**TOWN OF MOUNTAIN VILLAGE
REGULAR DESIGN REVIEW BOARD MEETING
THURSDAY MARCH 28, 2019 10:00 AM
2nd FLOOR CONFERENCE ROOM, MOUNTAIN VILLAGE TOWN HALL
455 MOUNTAIN VILLAGE BLVD, MOUNTAIN VILLAGE, COLORADO
AGENDA**

DATE: March 18, 2019
TO: Design Review Board
FROM: Sam Starr, Planner
FOR: DRB Public Hearing on March 28, 2019
RE: Consideration of a Design review application for CeDUR synthetic roofing, which requires a specific approval from the DRB, on Lot 601 Unit 34, 307 Fairway Drive.

TO: Design Review Board
FROM: Sam Starr, Planner
FOR: Meeting of March 28,2019
DATE: March 21, 2019
RE: Consideration of a Design Review: Initial Architectural Site Review application for a new single-family dwelling on Lot 165-13, 230 Cortina Drive.

PROJECT No.	DATE	
20182606.00	11/13/2018	
DRAWN BY	CHK BY	TRV BY
JB	TL	
SHEET No.	H1.00	
SCALE:

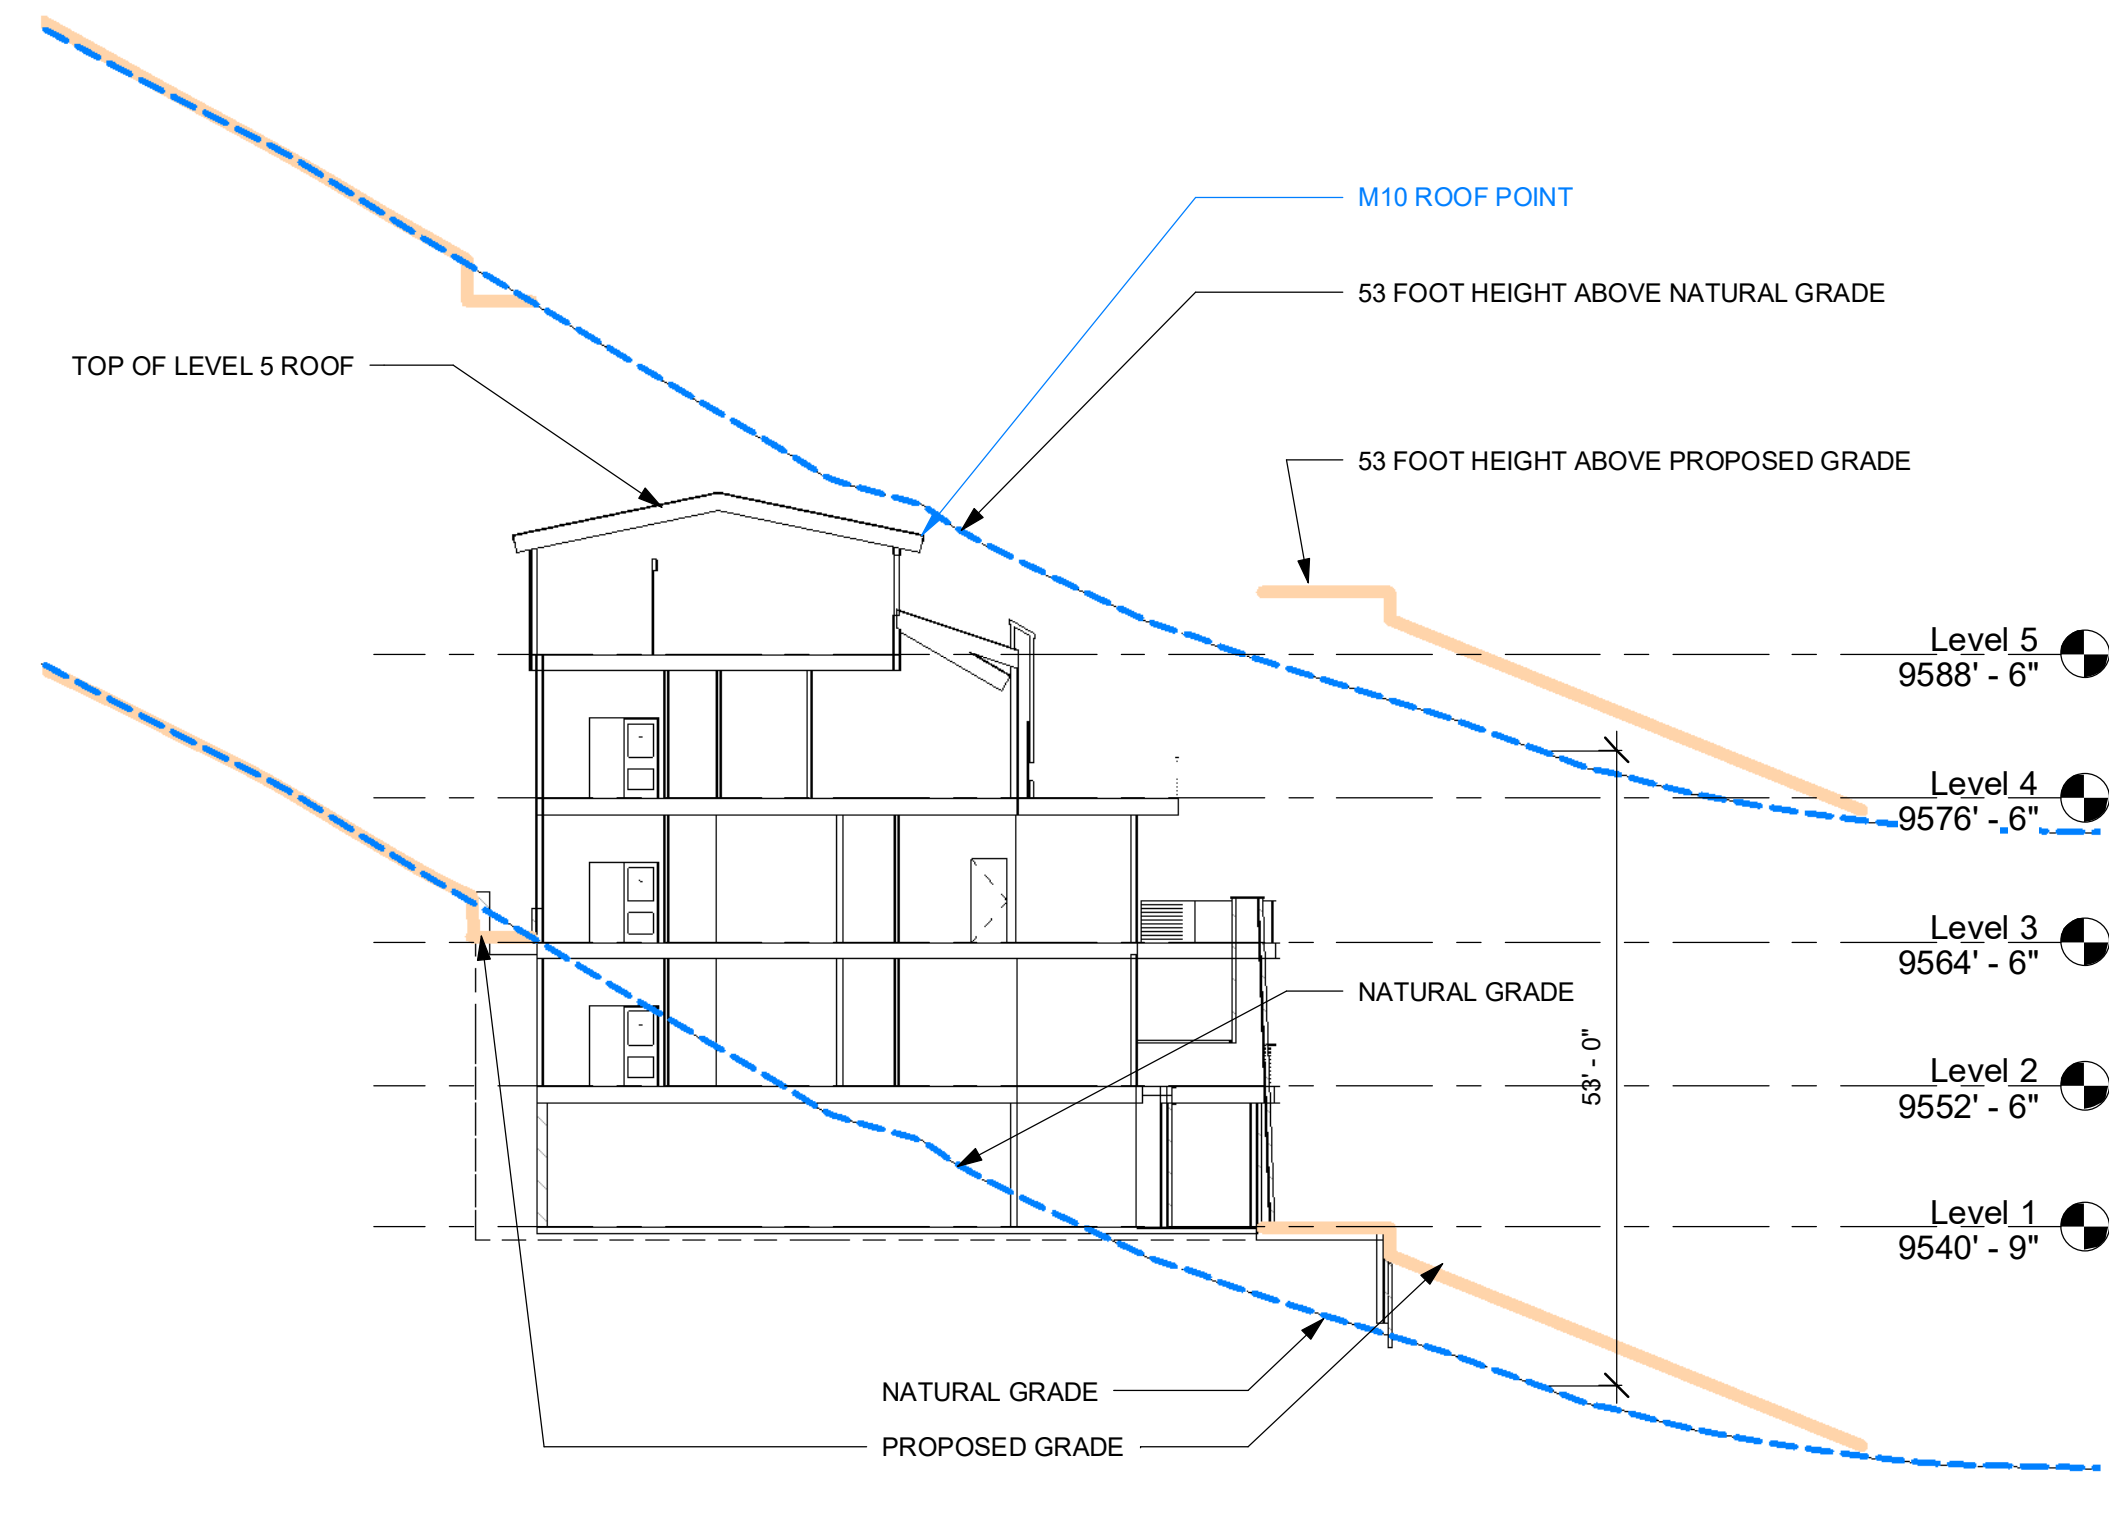
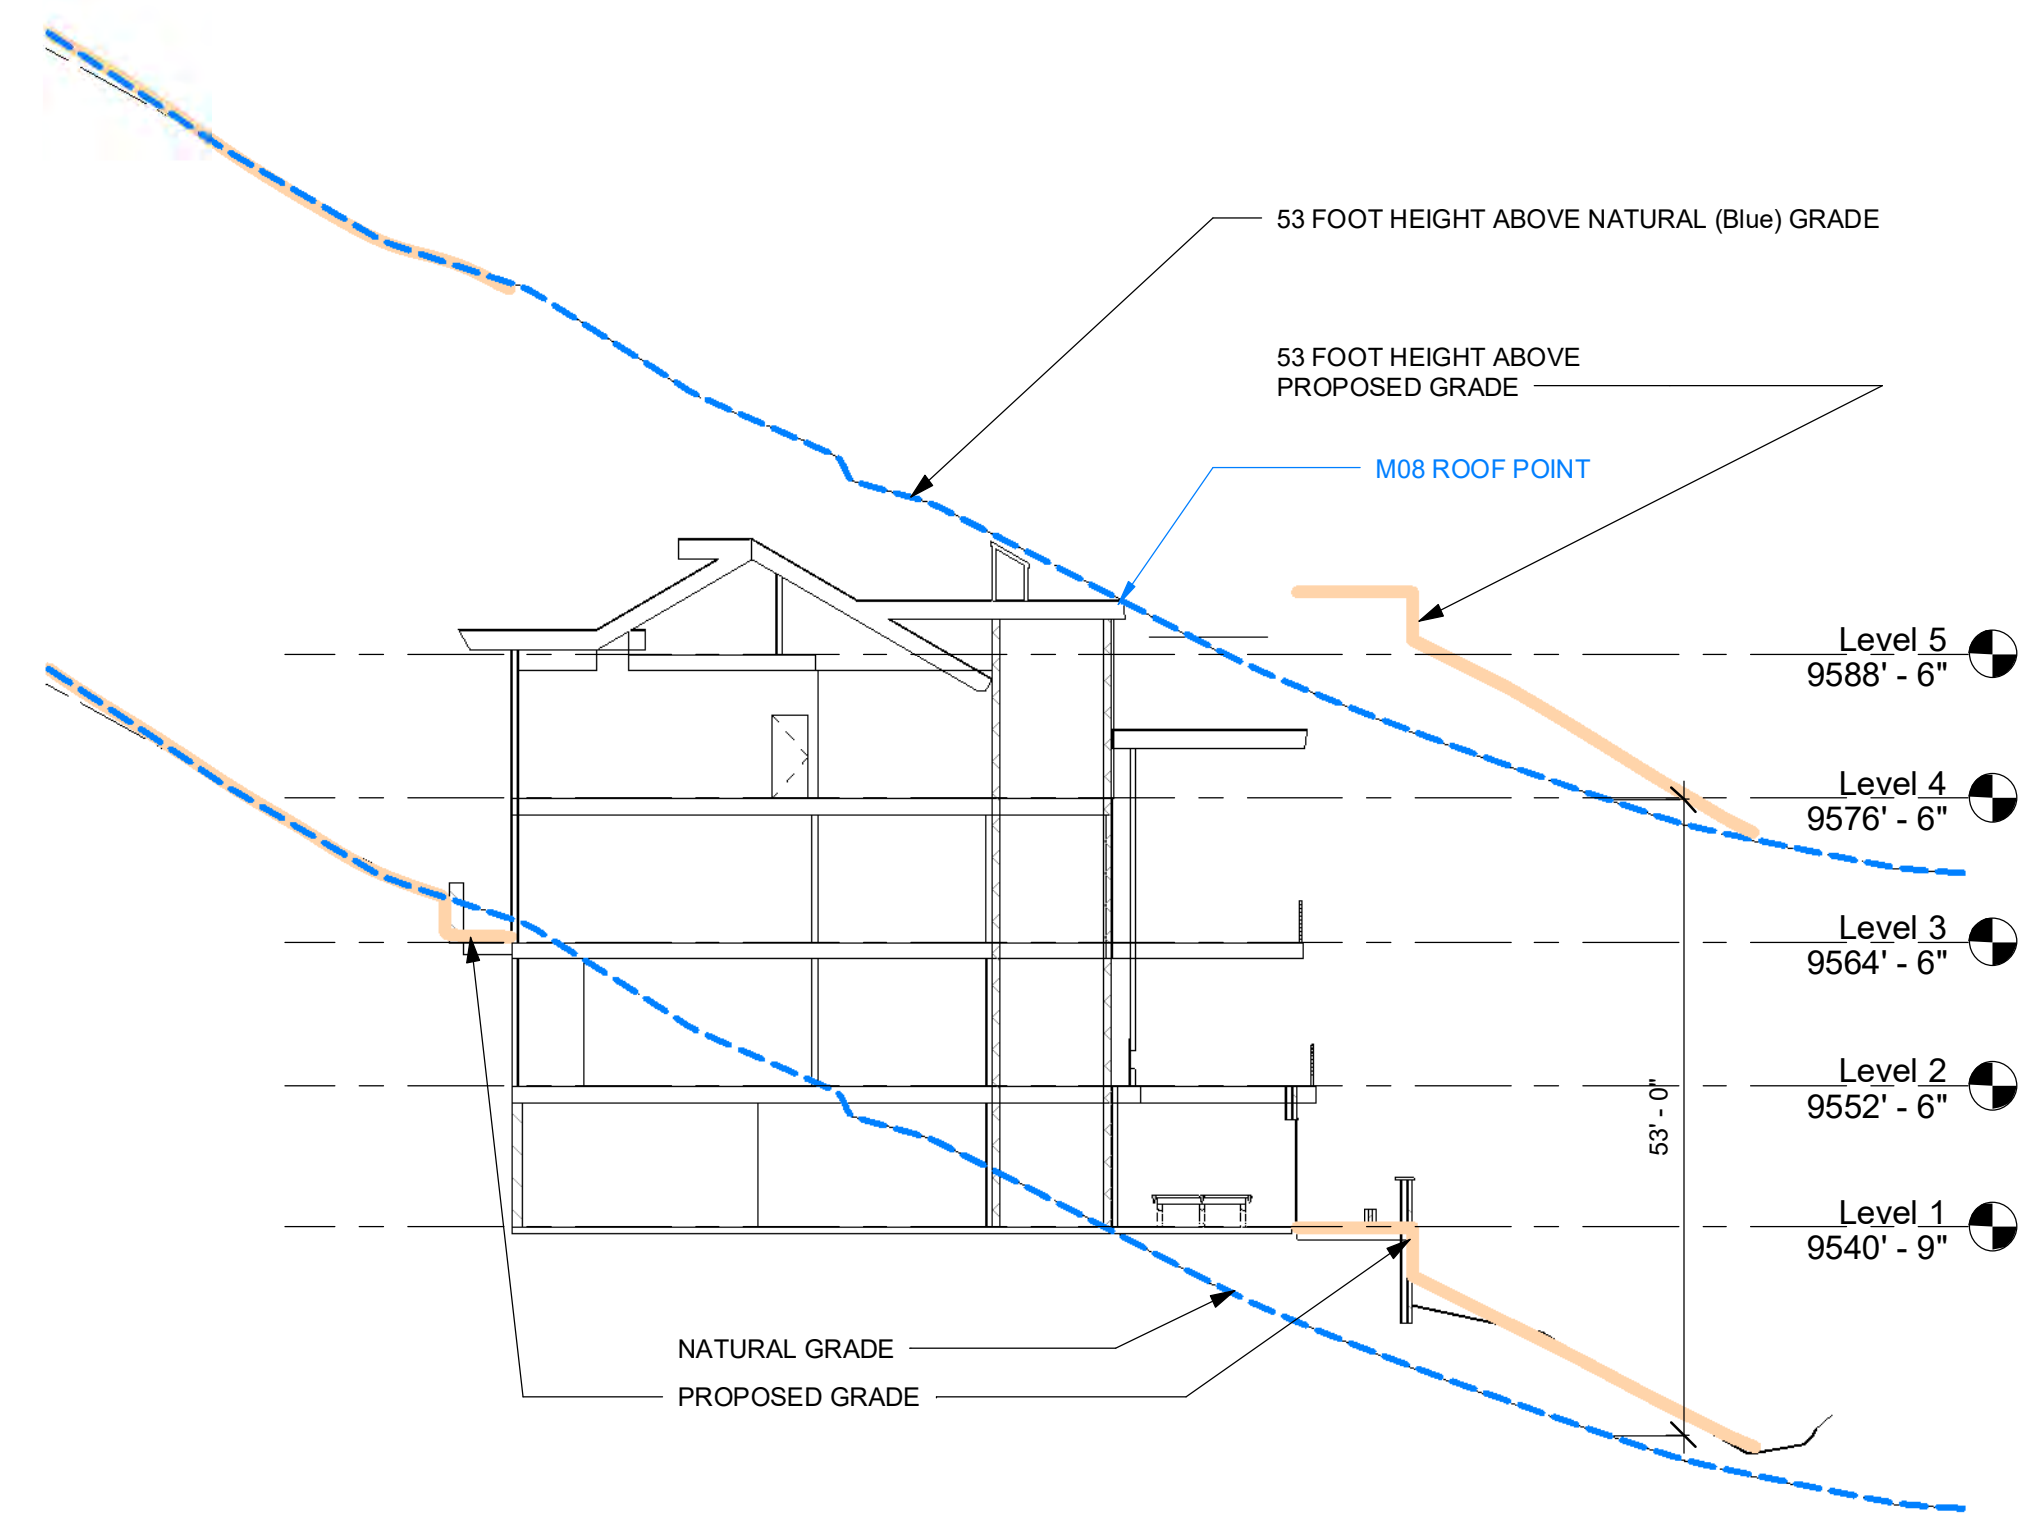
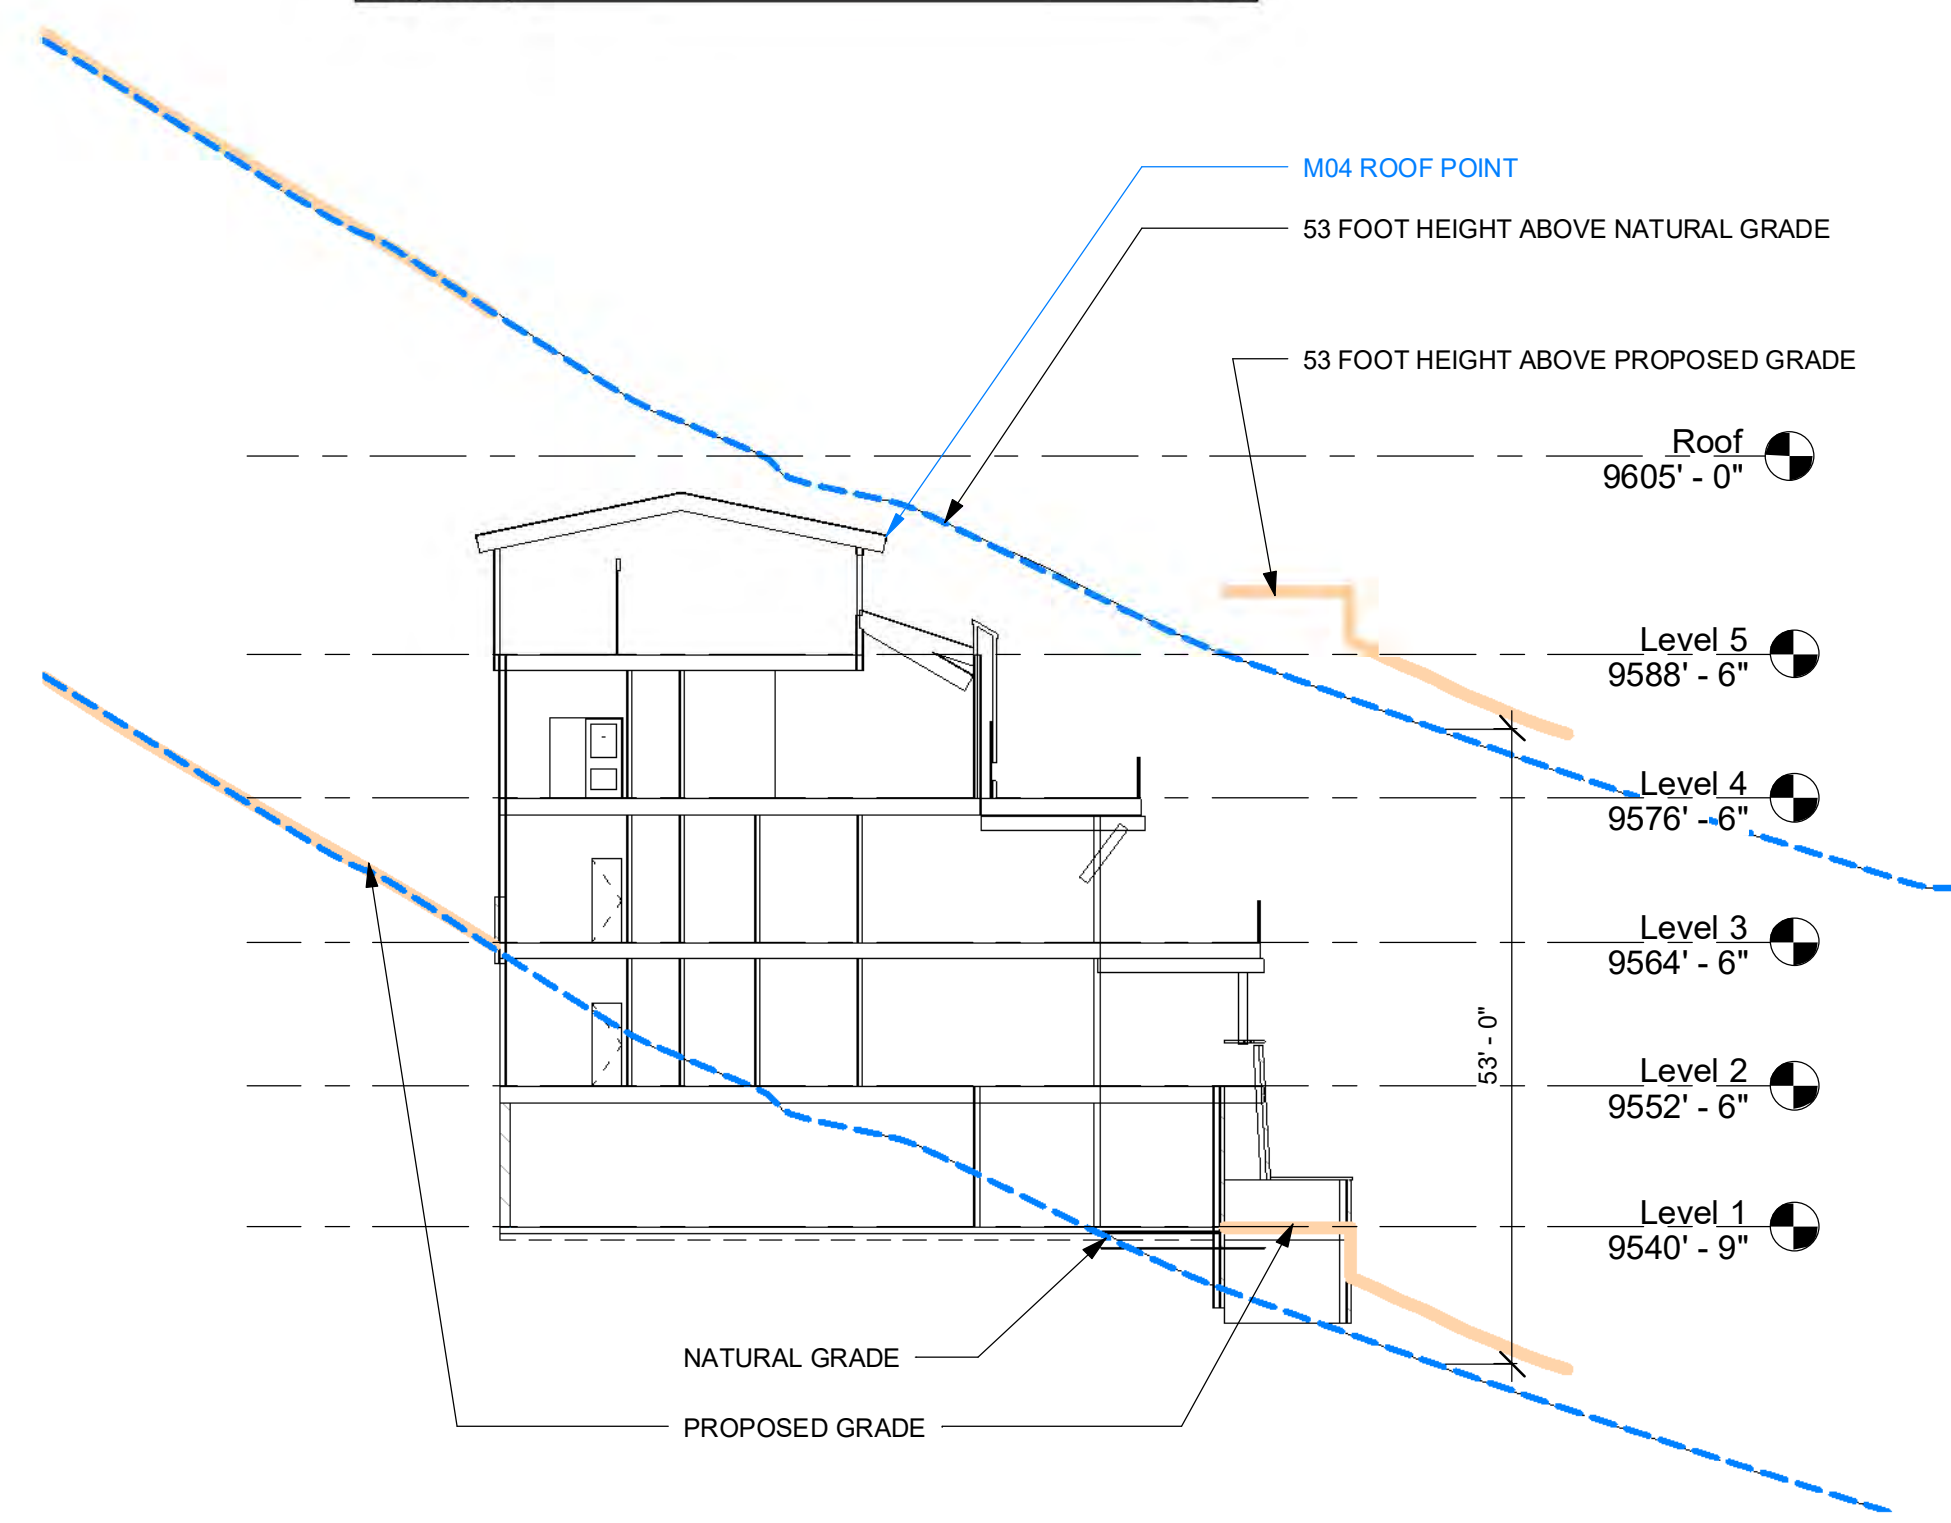
Staff: The applicant has provided a height analysis that demonstrates both Maximum Roof Height Calculations as well as Average Maximum Roof Height Calculations. According to page H1.00 of the plan set, the average height for the proposed designed is compliant at 39.79 feet and the highest point above the most restrictive grade is M08 which has a max height of 52.91 feet. The applicant has provided an average height analysis demonstrating all measurement points above the most restrictive grade, along with elevations demonstrating the height analysis showing a parallel slope analysis demonstrating compliance and all areas other than those in which the chimney penetrates the 53-foot parallel slope of nature.
